**NSLPP MEETING HELD ON 6/12/23****Attachments:**

ADDRESS/WARD: 201 Miller Street, North Sydney (CBD)**APPLICATION NO:** DA145/23**PROPOSAL:** Replacement of existing window shrouds and repairs and maintenance of the façade of a 23-storey commercial building and heritage-listed item**PLANS REF:**

OWNER: The Trust Company (Australia) Limited**APPLICANT:** Urbis Pty Ltd**AUTHOR:** Report of Rachel Wu, Graduate Assessment Officer**DATE OF REPORT:** 13 November 2023**DATE LODGED:** 23 May 2023**RECOMMENDATION:** Deferral

Figure 1: Proposed façade replacement on all elevations

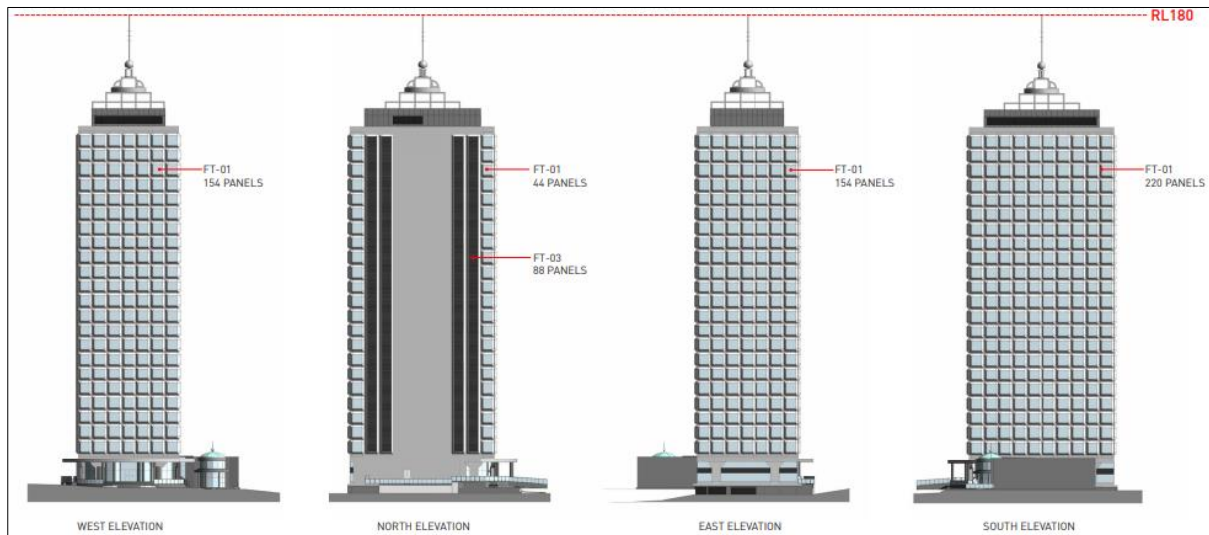
The application has been referred to Council's Conservation Planner and the Design Excellence Panel for consideration due to the scope of works involving substantial recladding to a highly distinctive building. Both the DEP and Council's Conservation Planner consider that the current proposal should not be accepted on the basis that the proposed design and fabrication of the window shrouds and the selected white powder coated aluminium finish would diminish the heritage significance of the building and further improvement should be considered to the building.

Council has requested that the Applicant consider amendment to the scope of works to revise the fabrication standard of the proposed window portal structures, as well as amend colour selection for the façade to match the original orange building façade. The Applicant has yet to indicate agreement to the requested changes. Considering the potentially significant change in the scope of works, the Panel is requested to consider the application in its current form.

On the basis of the advice of Council's Conservation Planner and DEP, the current proposal is recommended for deferral with conditional support for determination that requires amended plans and additional information addressing the colour scheme, unitary fabrication, deletion of works to reveal the building's exoskeleton on the Northern Elevation, and removal of the portico to the main forecourt for the reinstatement of the original supporting column profiles.

**Figure 3 (left): 3D close up of proposed window shrouds and glazing
 Figure 4 (right): Proposed Section**

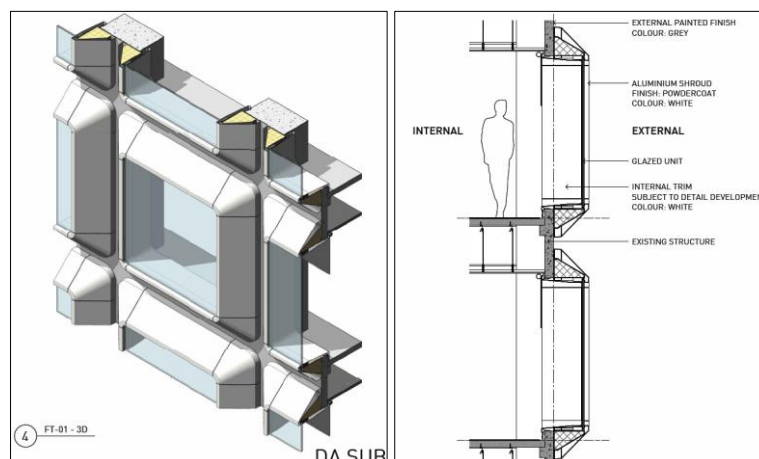
Council's Conservation Planner and the Design Excellence Panel have considered the current proposal and recommended that the application should not be accepted on the basis that the proposed design and fabrication of the window shrouds and the selected white powder coated aluminium finish would diminish the heritage significance of the building and further improvement should be considered to building.

Council has requested that the Applicant consider amendment to the scope of works to revise the fabrication standard of the proposed window portal structures, as well as amend colour selection for the façade to match the original orange building façade. The Applicant has yet to indicate agreement to the requested changes. Considering the potentially significant change in the scope of works, the Panel is requested to consider the application in its current form to provide further guidance to the applicant on the appropriate form that any recladding should take.

The application is recommended to the Panel for deferral for conditional support of the application on the basis that the Applicant prepare, and lodge amended plans and additional information incorporating the following changes:

Figure 7h: Existing building (left) and amended design (September 2022) on right

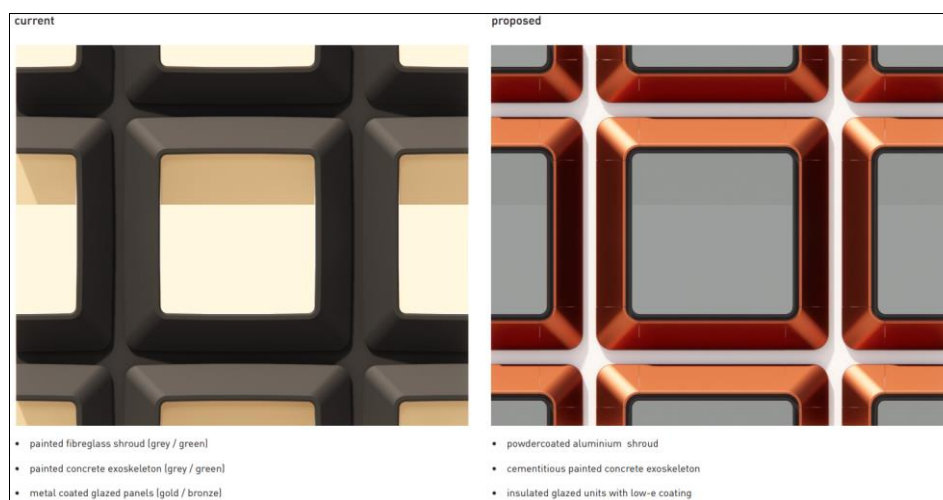
- Council's Conservation Planner deemed the new form of the shroud with shadow line acceptable. The glazing is not protruding beyond the shroud.
- Council's Executive Assessment Officer recommended that the building facade works could form a separate Development Application.

- Council's Executive Assessment Officer requested a new model to be sent in.
